ADDENDUM No. 1

Project Name:	Owner: City of Dexter Project Name: Dexter City Hall Renovations	Addendum No: One (1)
Project Number:	21-113	Issue Date: January 21, 2022
Project Location:	3515 Broad St. Dexter, Michigan 48130

SHEET NO.
A0-03

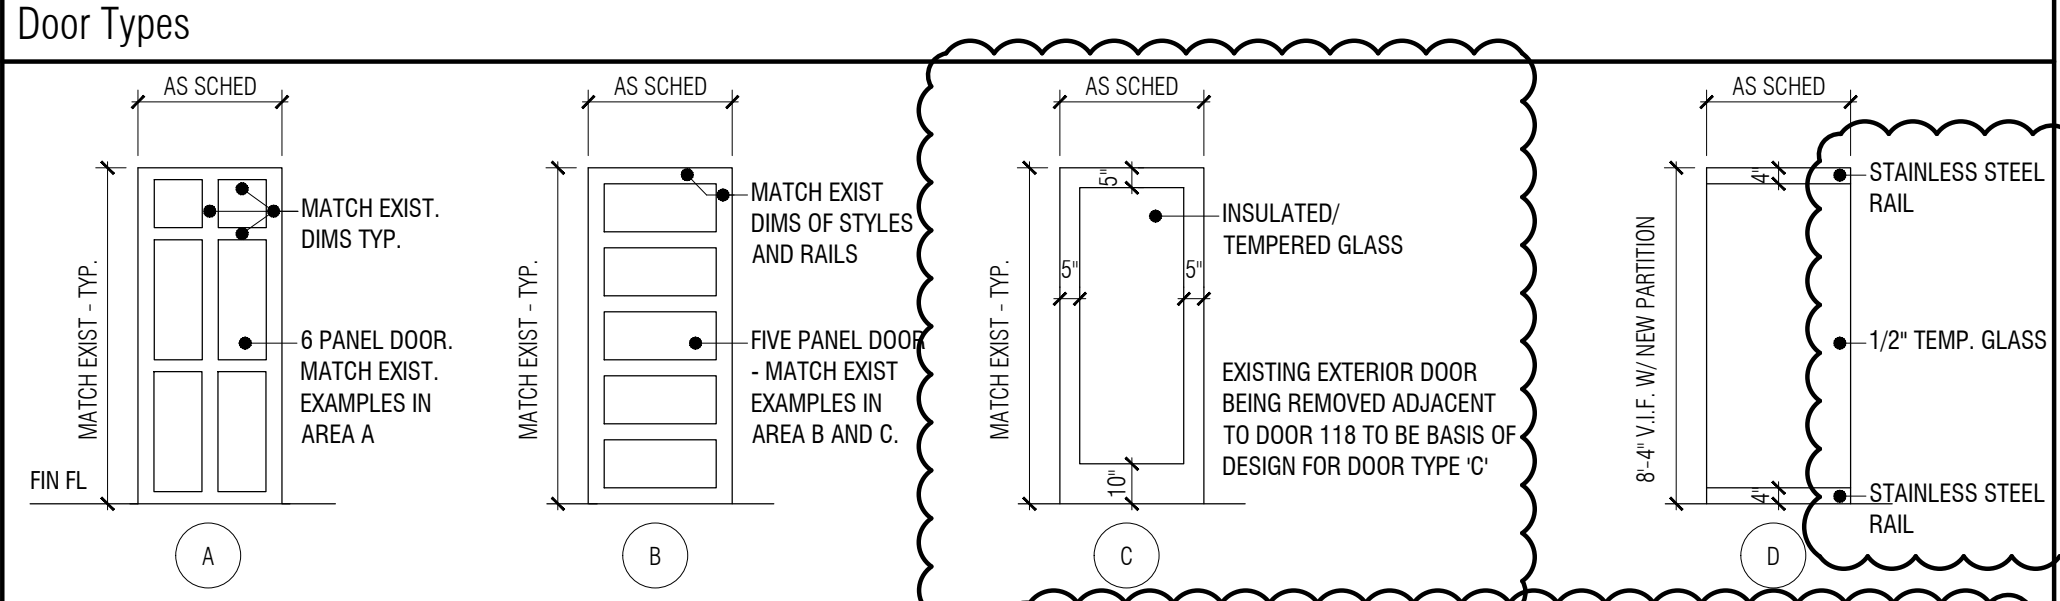
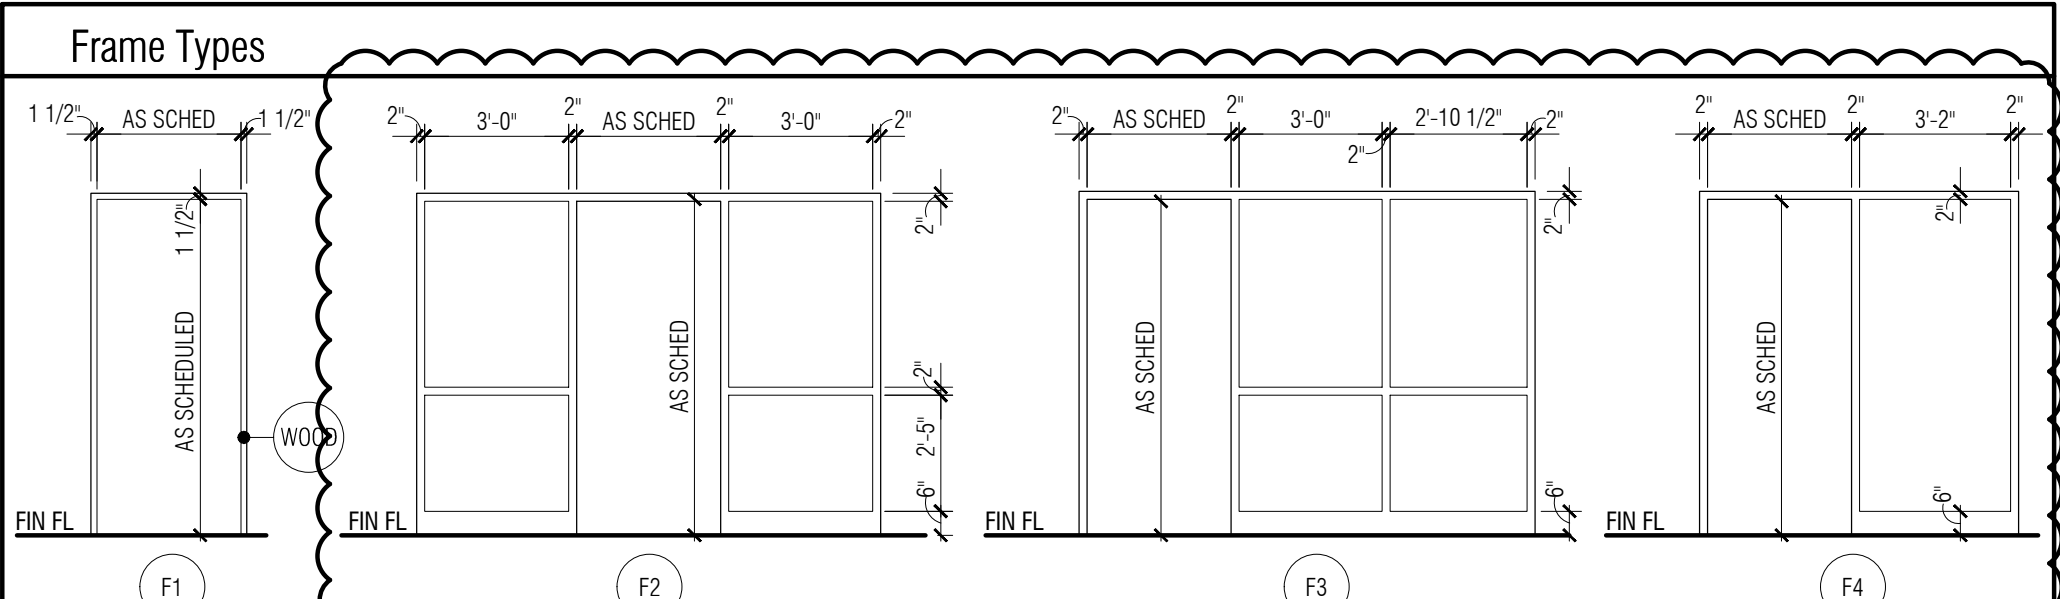
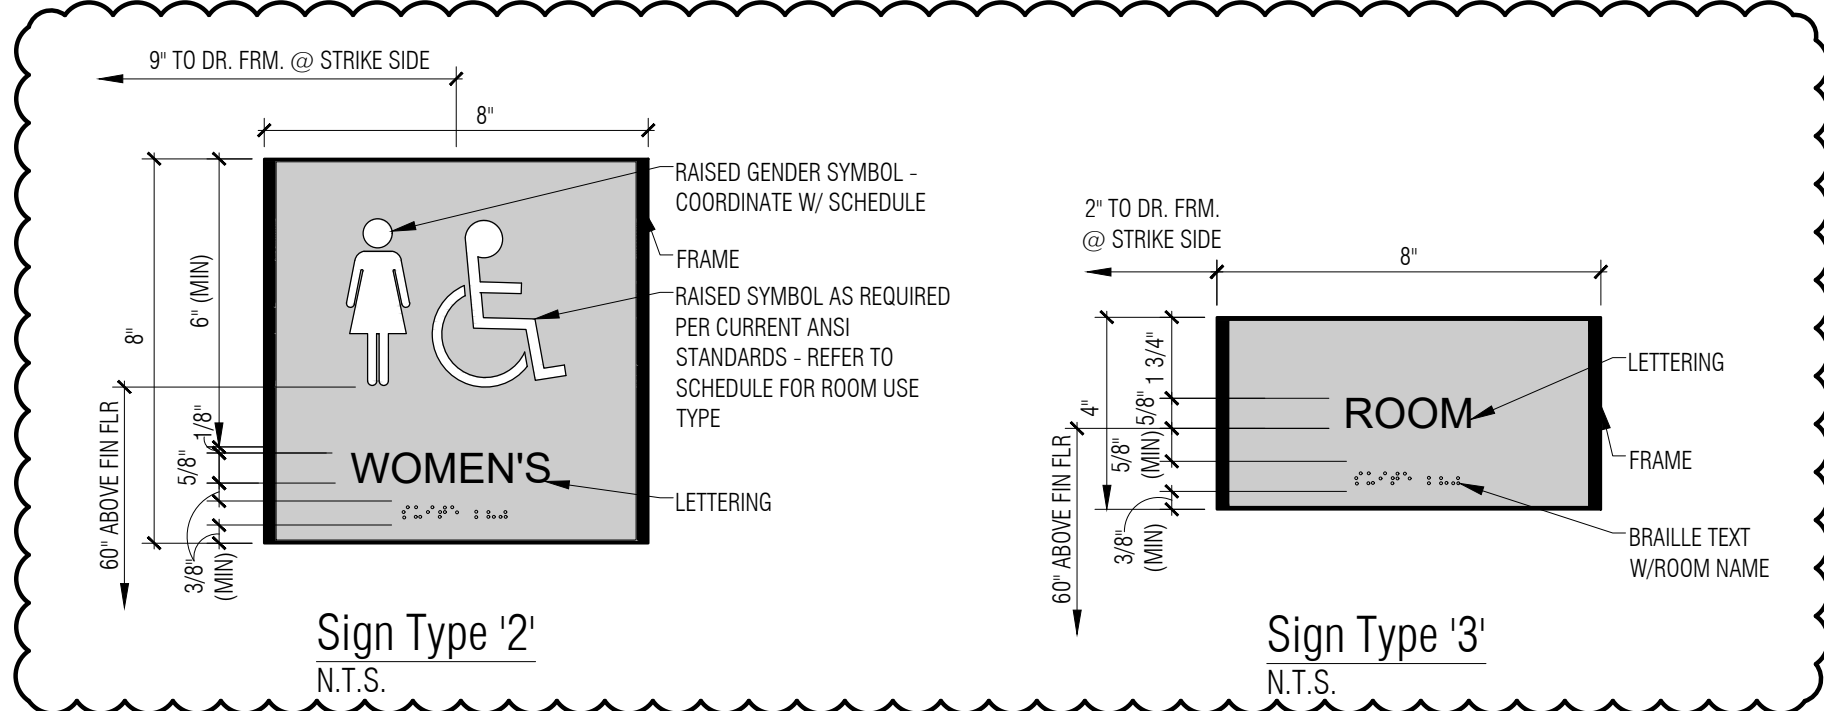
- ITEM A2** A0-03 Schedules, Door, Frame, & Wall Types (Revised & Re-Issued)
A. Updated door schedule with head, jamb, and threshold details.
B. Updated door schedule to more clearly indicate what doors are existing to remain.

C. Modified wall type 4 to indicate a solid surface topper.
D. Added wall type 1E to fulfill need for walls with no ceiling at top.
E. Added door frame type F4, and applied to door 118.

F. Door frames F2 & F3 are now aluminum storefront, not wood.
G. Added horizontal mullion to frame type F2.
H. Added note for door type C for basis of design.

I. Updated floor & base type for rooms 129 & 206.
J. Added room finish keynote 4, and applied to room 129.
K. Added door keynote 1 to legend, and applied to doors 101, 102, & 118.

L. Added general details for interior signage.
M. Updated door 104 to be 8'-4" tall, rather than 7'-0".
- ITEM A3** A0-04 Typical Opening Details (Revised & Re-Issued)

ARCHITECTURAL
SITE PLAN

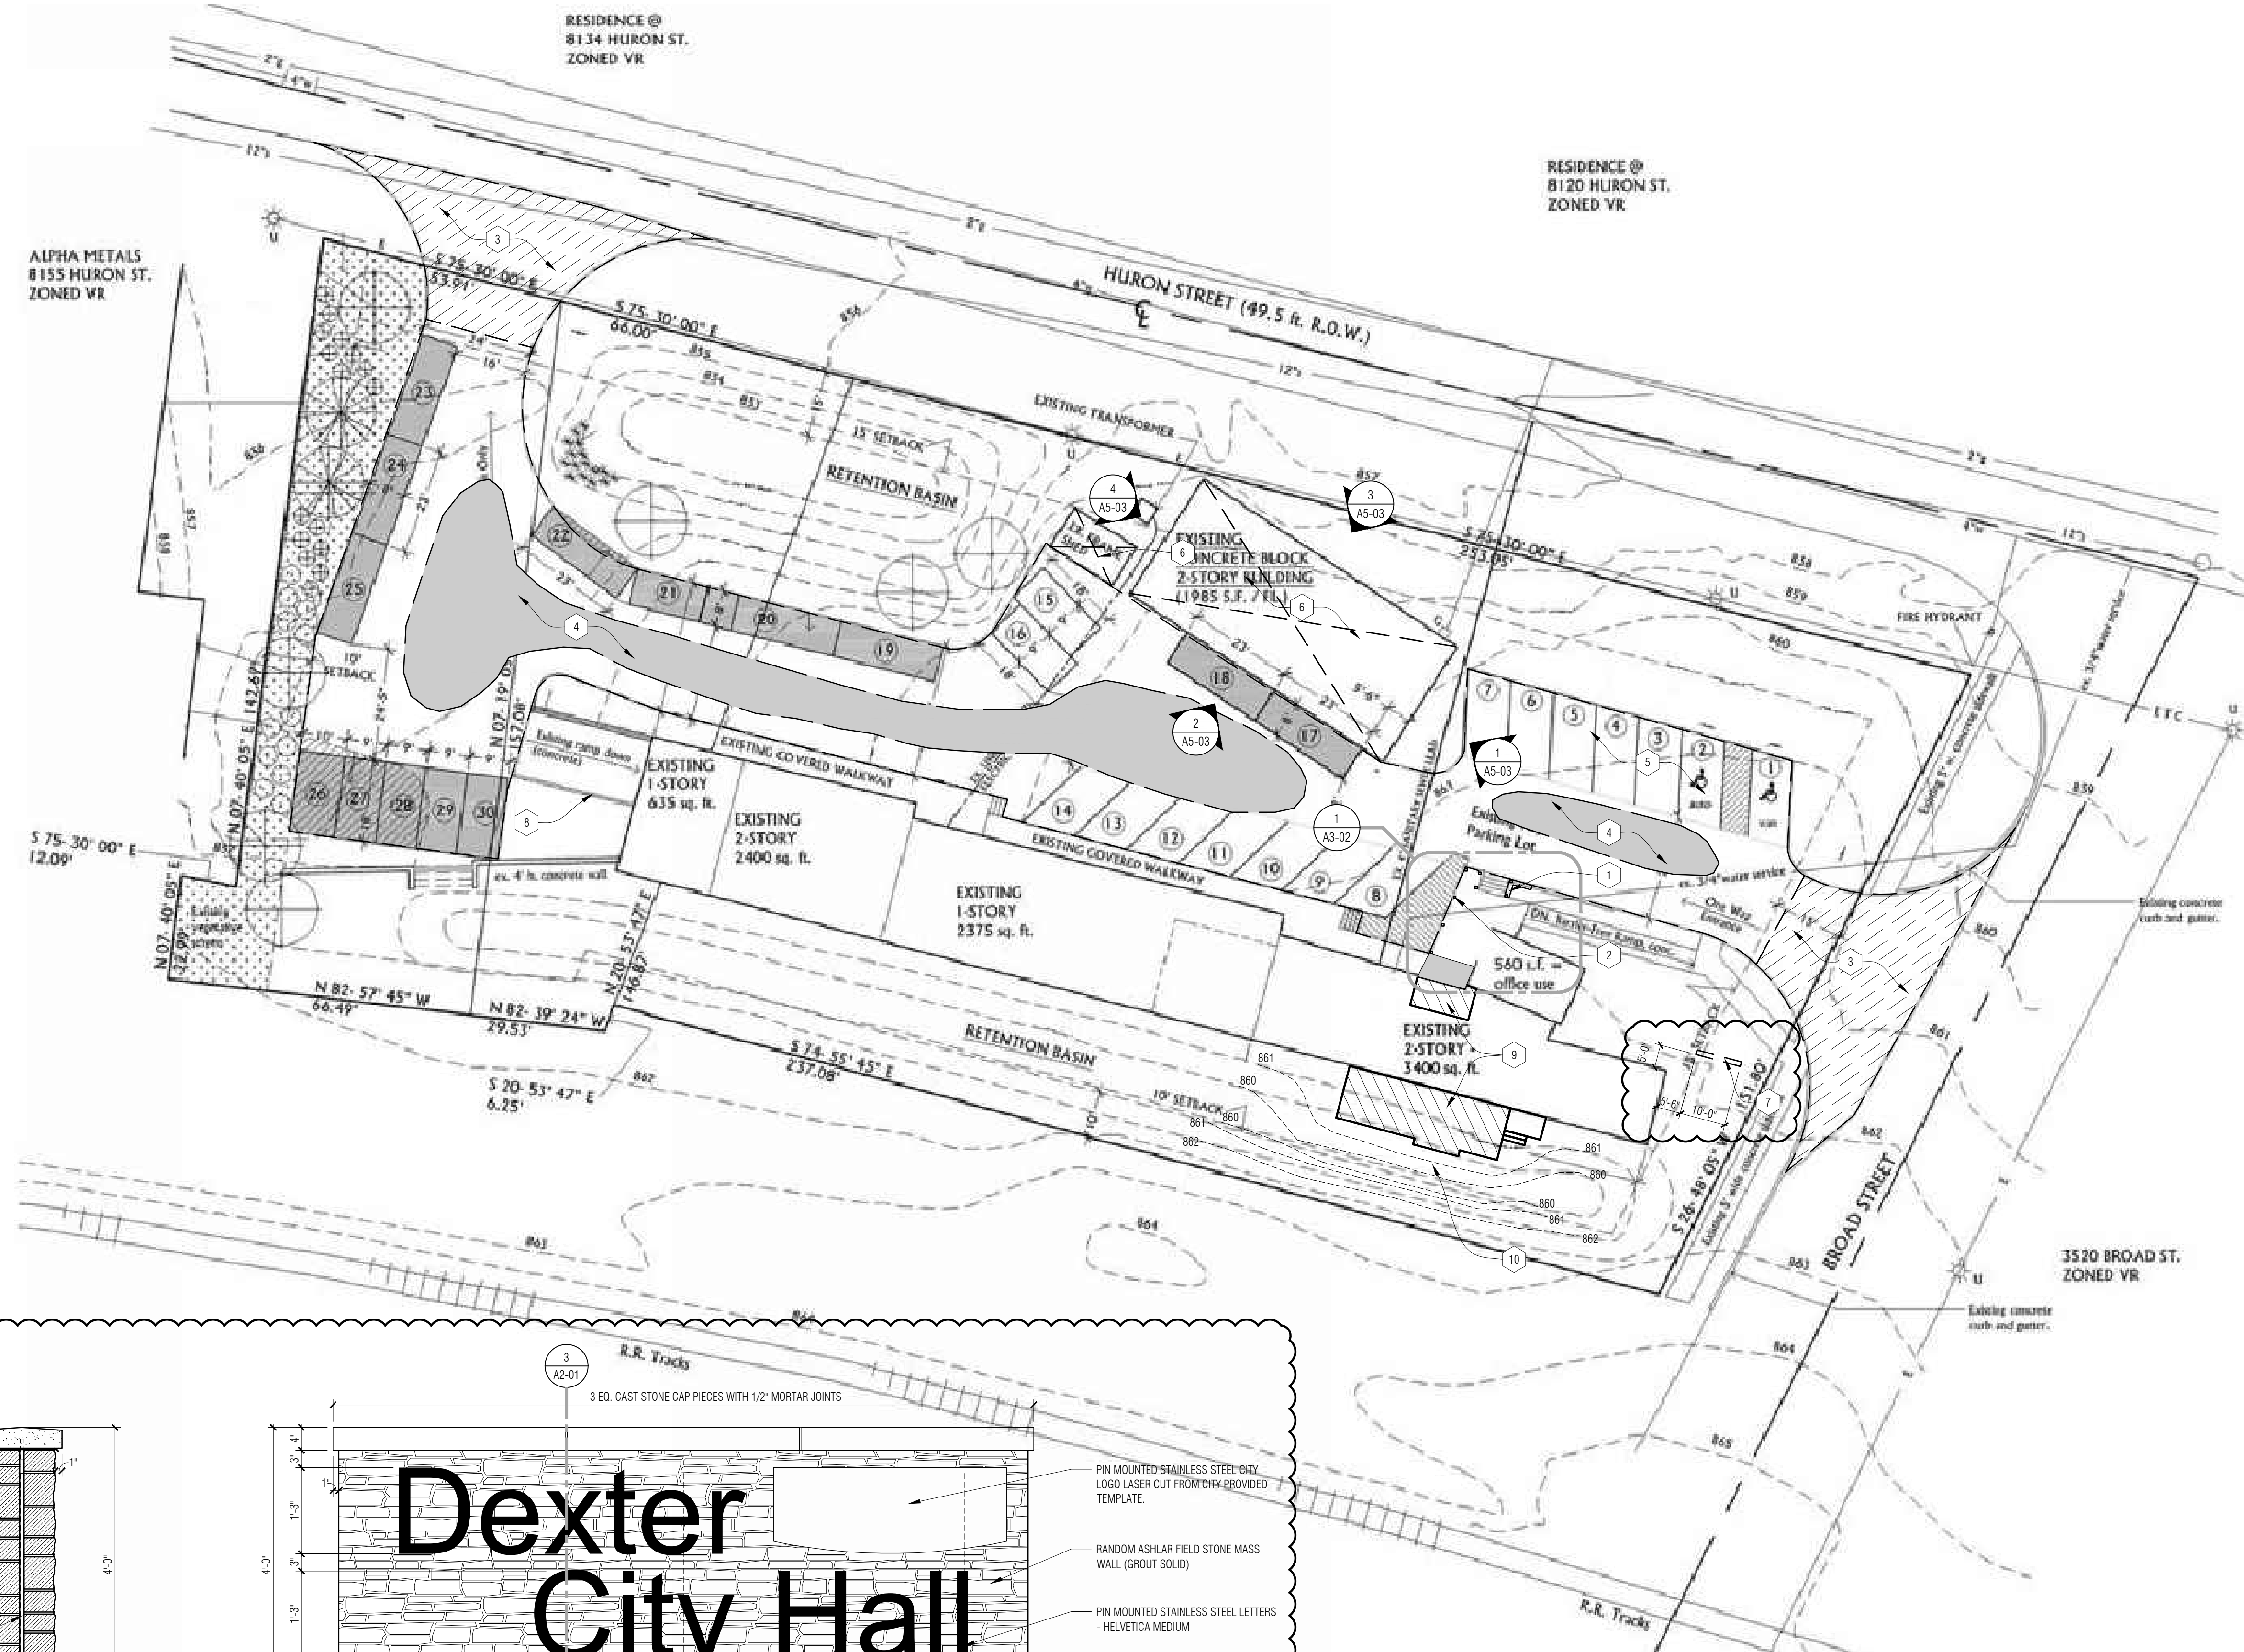
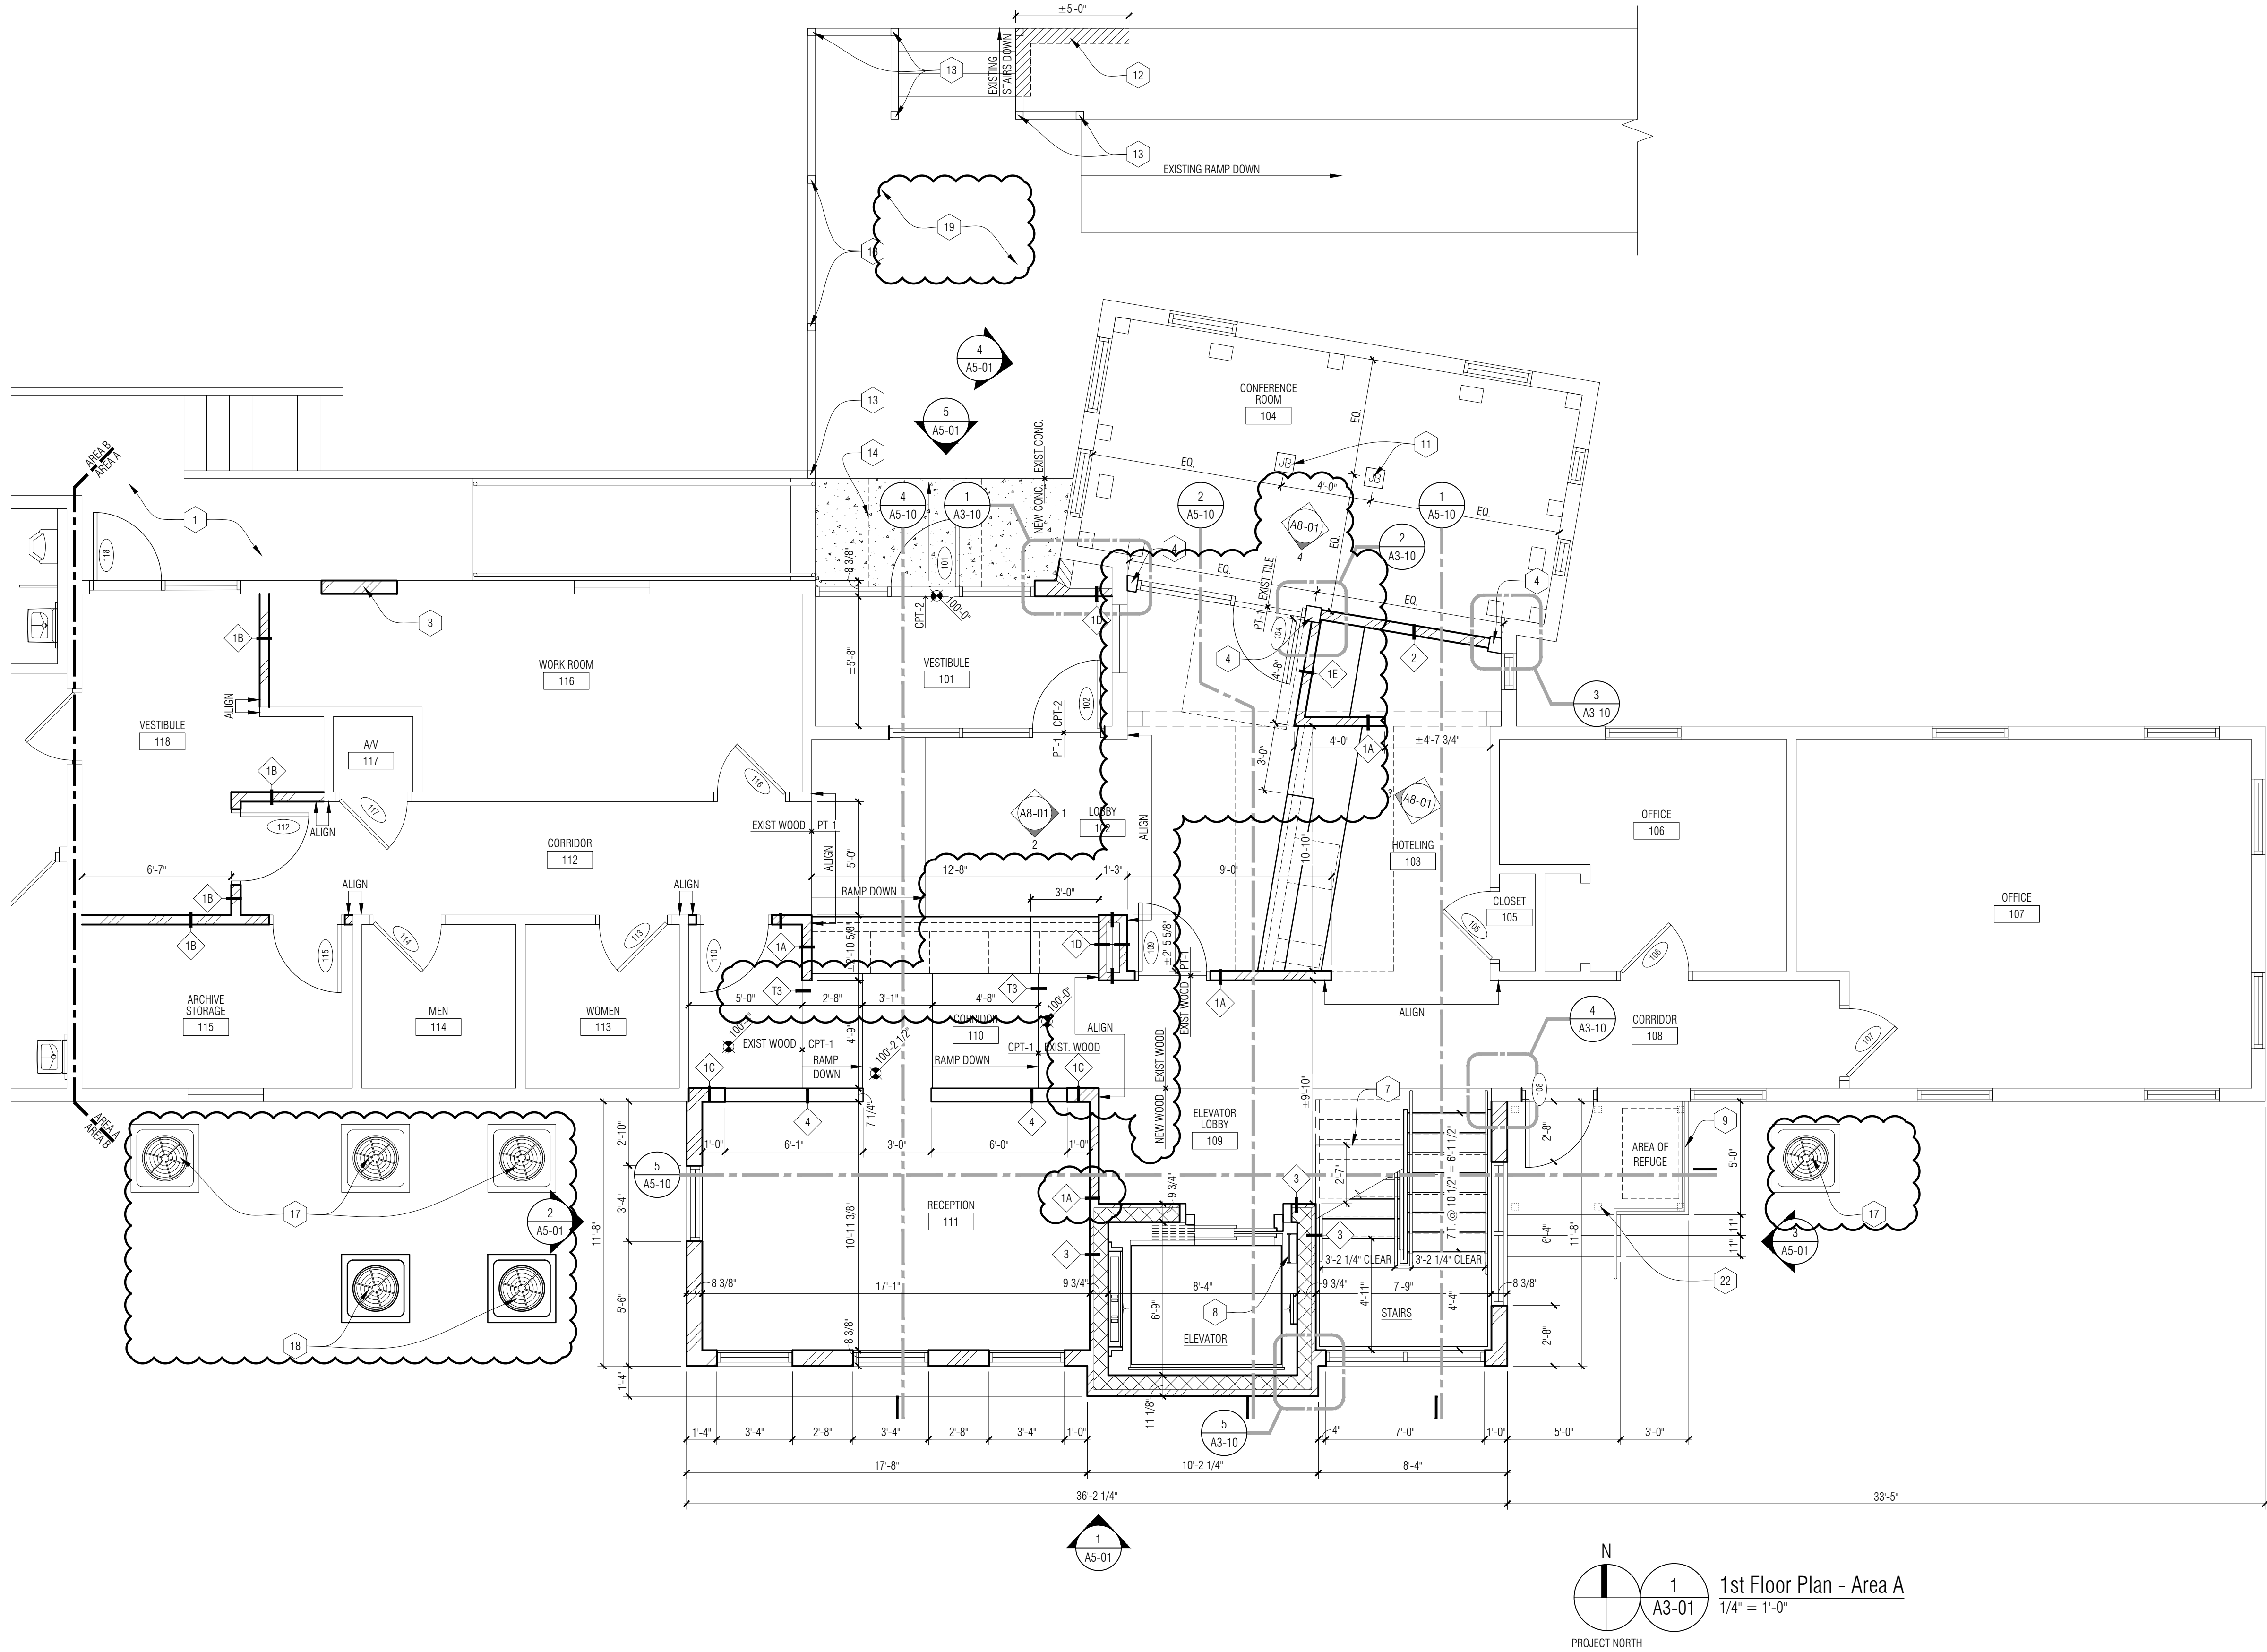
- ITEM A9** A2-01 Architectural Site Plan (Revised & Re-Issued)
A. Adjusted location of monument sign.
B. Added monument sign elevation and section.
- ITEM A10** A3-01 Basement Floor Plan – Area A (Revised But Not Re-Issued)
